**RE: Comments of Renewable Northwest, Docket UE-200304**

Utilities and Transportation Commission’s January 5, 2021, Notice of Opportunity to File Written Comments Relating to Puget Sound Energy’s 2021 Final Integrated Resource Plan for Electricity, Docket UE-200304.

Figure 1. Loss of Load Hour heatmap for PSE’s system in 2027 with winter super-peak windows highlighted.

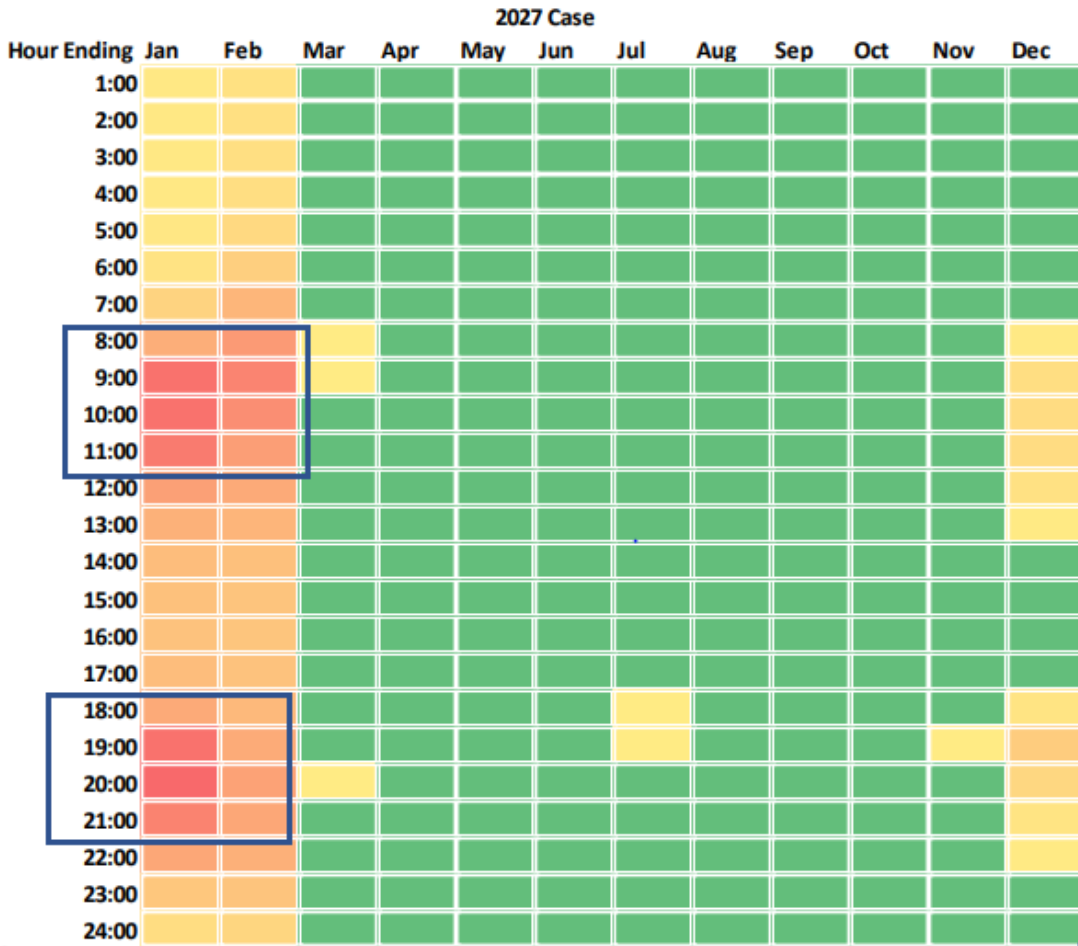
Before we filed our previous comments, we had understood that PSE staff would run a sensitivity allowing the model to select from a *mix* of storage options, notably 4-hour lithium-ion batteries and 8-hour pumped hydro storage. Renewable Northwest was concerned and disappointed to see that this portfolio sensitivity was not included in both the Draft and Final IRP. PSE’s capacity needs occur mostly during winter mornings and evenings in the months of January and February as per the LOLP heat map shown below and shared in the Final IRP (Figure 3-11). To meet these needs especially the highest loss of load hour windows highlighted in Figure 1, PSE could utilize a portfolio of clean, non emitting capacity resources to provide energy during the separate 4-hour windows instead of building assets which are underutilized and have the increasing risk of being stranded in a few years.

Meeting winter peak needs using non-emitting capacity resources including a combination of pumped hydro storage, battery storage, hybrids, efficiency, and demand response provides PSE an opportunity to be CETA compliant over the long term and invest in emerging technologies which are most likely to be status quo in the future due to fast-changing state and federal policy efforts, significant tax incentives, and rapidly decreasing capital costs.
